Appendix F: Agency Correspondence

Chuck Thompson from Dairyland Power Cooperative (DPC) gave a presentation that provided background information for the Q-1 161 kilovolt (kV) Transmission Line (Q-1).

IV. Q-1 Construction Plan for the Van Loon Wildlife Area

II. Updated Q-1 Construction Plan for the Van Loon Wildlife Area

Line Design Options

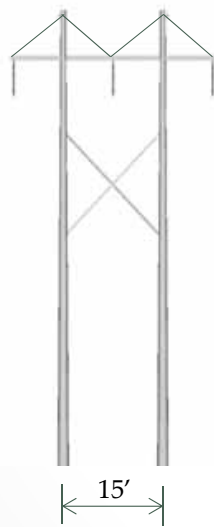
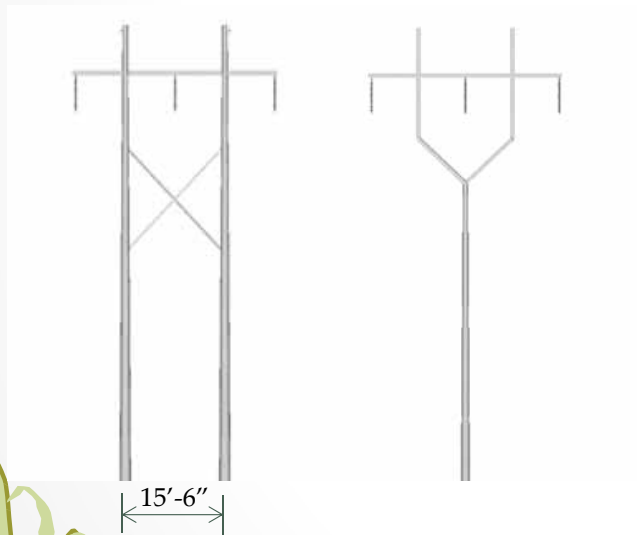
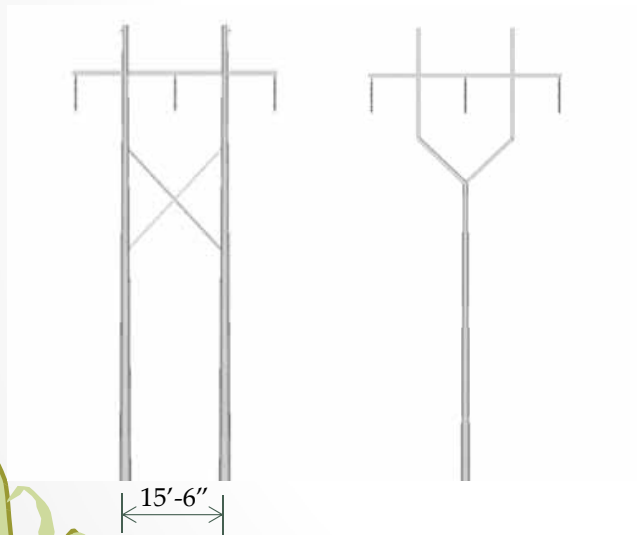
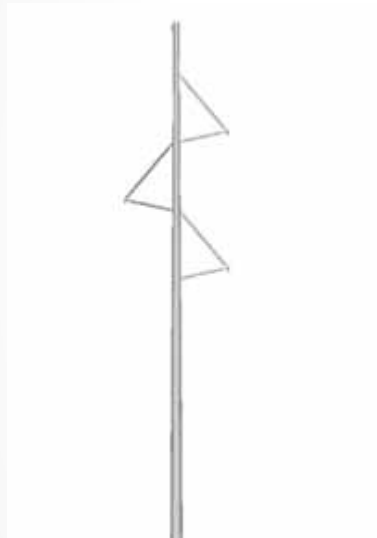
The Wisconsin Department of Natural Resources (WDNR) asked about the spacing of the delta sections. DPC stated that the first delta section would start approximately 35 feet above the ground and there was approximately 10 feet between each of the 3 sections and then 10 feet or so to the shield wire.

The U.S. Fish and Wildlife Service (USFWS) asked that the shield wire be kept at or below tree canopy height and asked about methods that could be used to reduce structure height. DPC will be determining average canopy height within the Van Loon and will look at options for reducing structure heights.

DPC proposes to rebuild the Q-1 through the Black River floodplain using helicopters and vibratory caissons. The Q-1 would be rebuilt using Y-Frame steel structures that are approximately 65 feet tall that would require a right-of-way (ROW) of approximately 65 feet. The Y-Frame steel structures would reduce the current ROW width from 80 feet down to 65 feet. The Y-Frame structures would also allow the Q-1 to be rebuilt at the current average tree canopy height of 65 feet. The new structures would need to be constructed at least 15 feet away from existing structures.

The revised design results in a reduction in the number of structures in the Black River floodplain from 22 to 21; reduces the number of structures on Wisconsin Department of Natural Resources (WDNR) and U.S. Fish & Wildlife Service (USFWS) land from 11 to 8; and since the Y-frame structures are single poles and the H-frame structures are double poles the number of poles are reduced from 44 to 21.
